From: JoAnn Fryer [jlf@cldengineers.com]
Sent: Tuesday, November 06, 2012 12:44 PM
To: Angela Blanchette
Cc: Ryan M. McCarthy; Kathleen J. Bassett
Subject: RE: Simpson Rd Bridge update (CLD#09-0248)
Attachments: FM2301550017D.pdf; Steel Backed Timber GR.pdf

Thank you for providing us with an opportunity to review the new report and respond. It appears that the report provided by Structures North is a thorough review of the material and provides a professional report with interesting insights and alternatives for the City to consider. There are a few items that we would like to note for the City's consideration in discussing the project and determining how to proceed:

Attached you will find Structures North's report, which evaluated CLD and DeGruchy's design and estimated costs. They have also provided a "hybrid" design. I will be meeting with our Adhoc committee next week and am interested to see if you have any comments on what John Watne provided.

MAP NUMBER
2301550017D

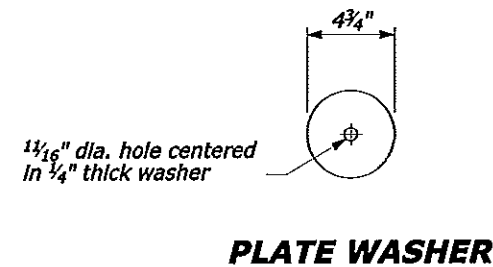
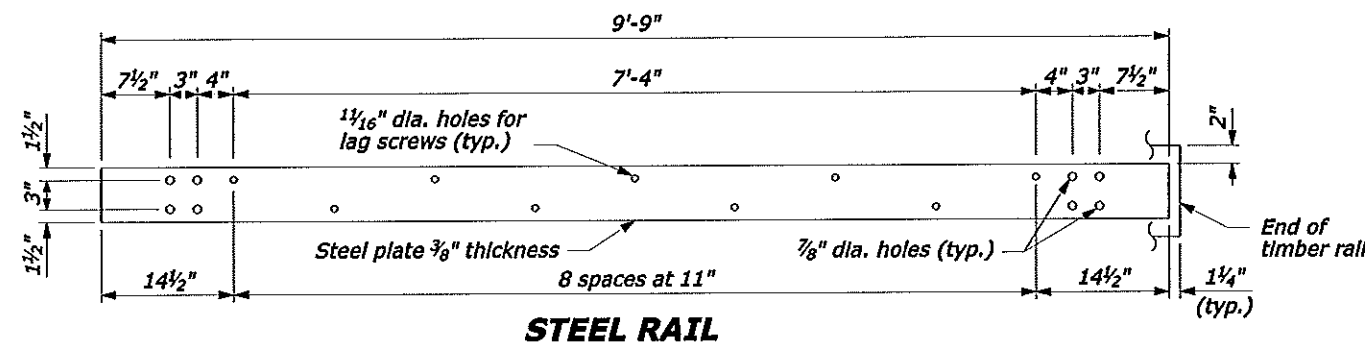
2. Hydraulic Capacity – Whether the intended purpose for the structure width was to control flow on the stream, the current configuration creates risk, both to the structure and the roadway (ie. the traveling public), as well as upstream properties. Per the attached excerpt from the FEMA Flood Insurance map, the backwater from the Saco River extends up Stackpole Creek to within several hundred feet of the bridge. Given this close proximity, increasing the hydraulic capacity of the crossing should not have detrimental downstream effects as water surface elevations are controlled by the much larger Saco River. As stated in all the reports, rehabilitation will not address the hydraulic capacity issue. The City may determine that the value of the structure outweighs the flooding risk.

U.S. DEPARTMENT OF TRANSPORTATION FEDERAL HIGHWAY ADMINISTRATION FEDERAL LANDS HIGHWAY	
U.S. CUSTOMARY STANDARD	
STEEL-BACKED TIMBER GUARDRAIL TYPE A & TYPE B	
STANDARD APPROVED FOR USE 3/1990 REVISED: 4/1994 6/2005	STANDARD 617-60

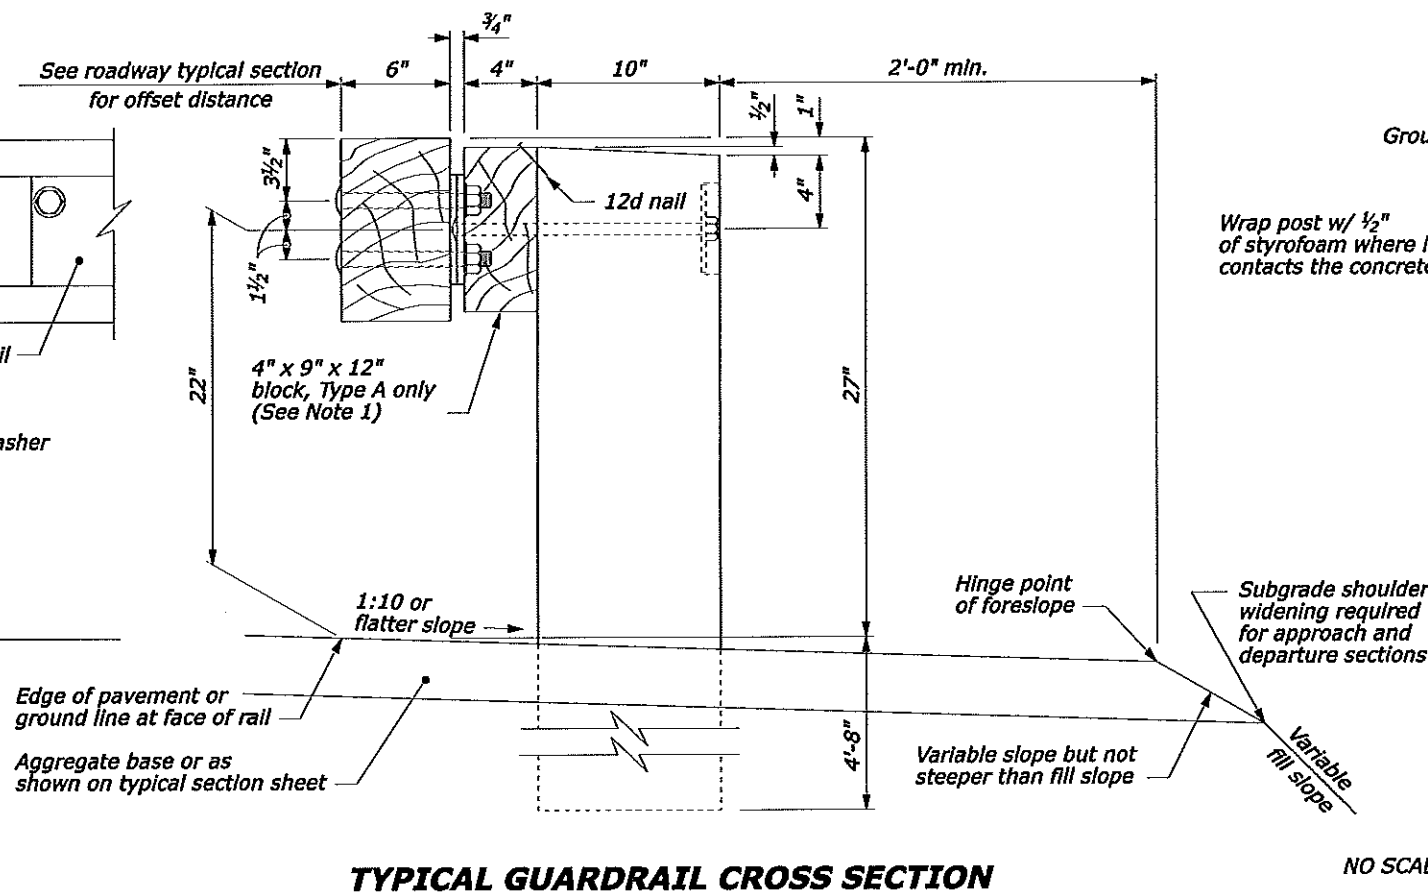
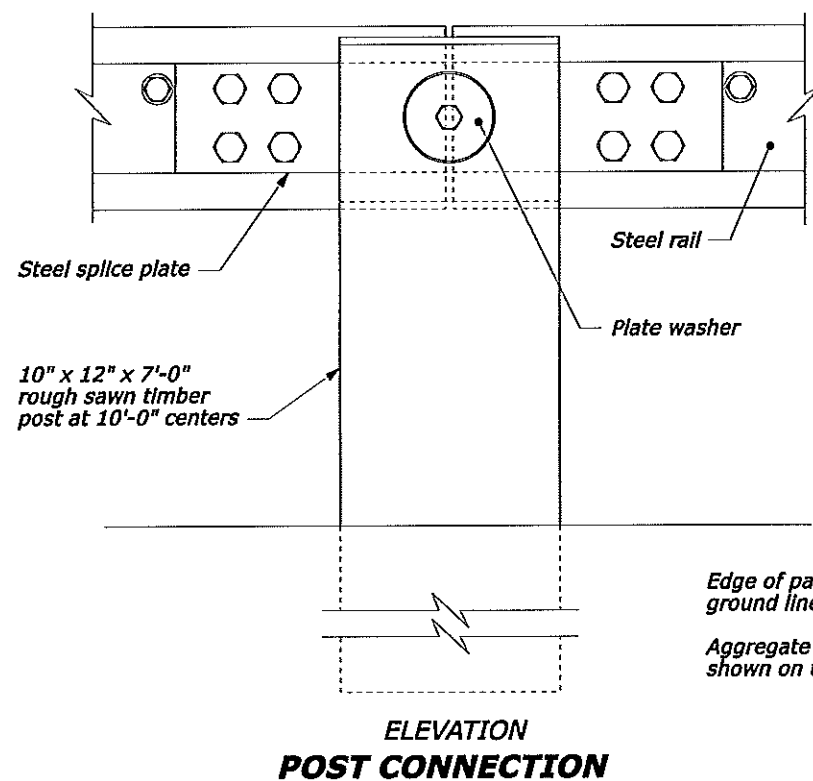
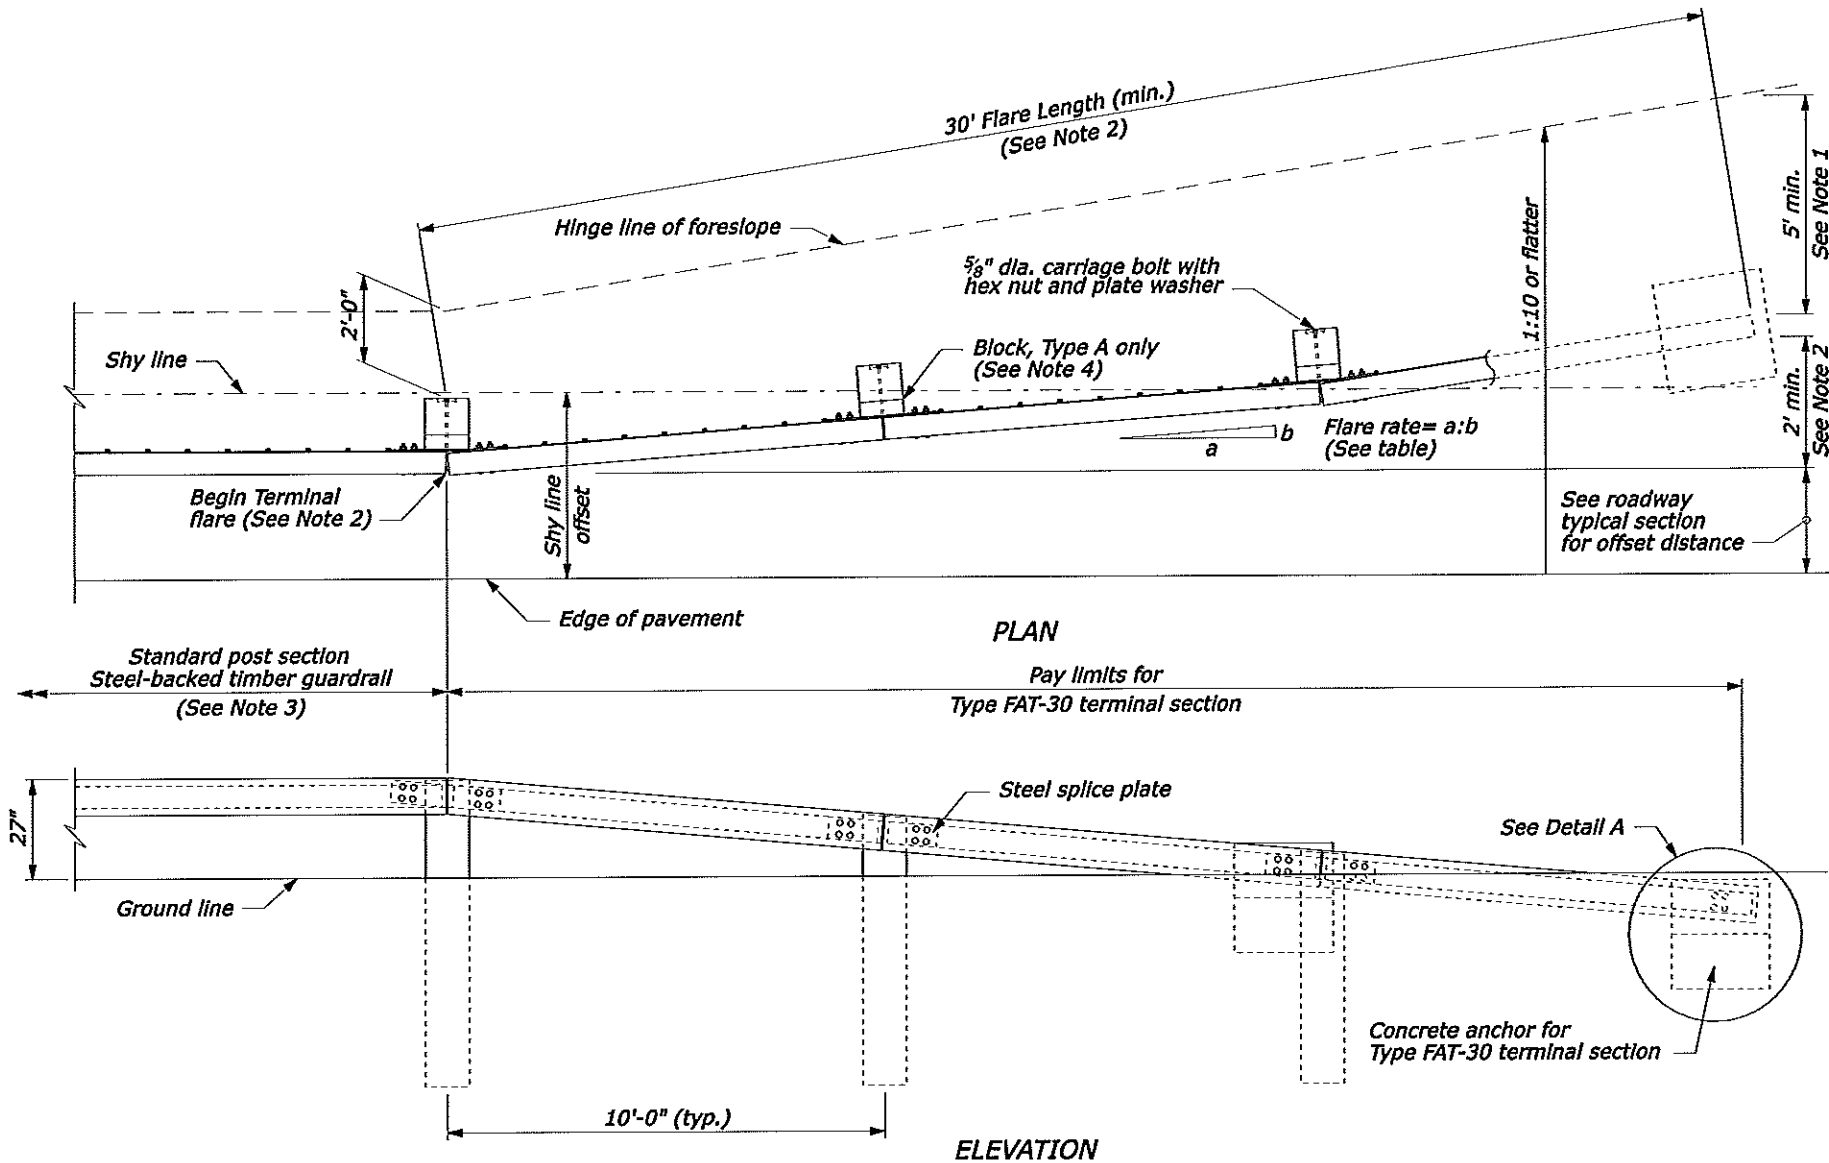
3. Guardrail – MaineDOT does not have a standard timber rail, although FHWA has a standard, crash-tested railing system "Steel-Backed Timber Guardrail". We have used this on several rural projects, and have recently obtained quotes for another location where the prices were in the range of \$80 to \$100/LF, significantly higher than regular beam guardrail. The City could use a non-crashed tested timber system which would likely cost less (no steel rail backing), however, would need to assume liability for a non-crash tested system (which would certainly be an improvement over the existing wheel axles in regards to safety). I have attached the FHWA standard plans for this railing if you are interested.
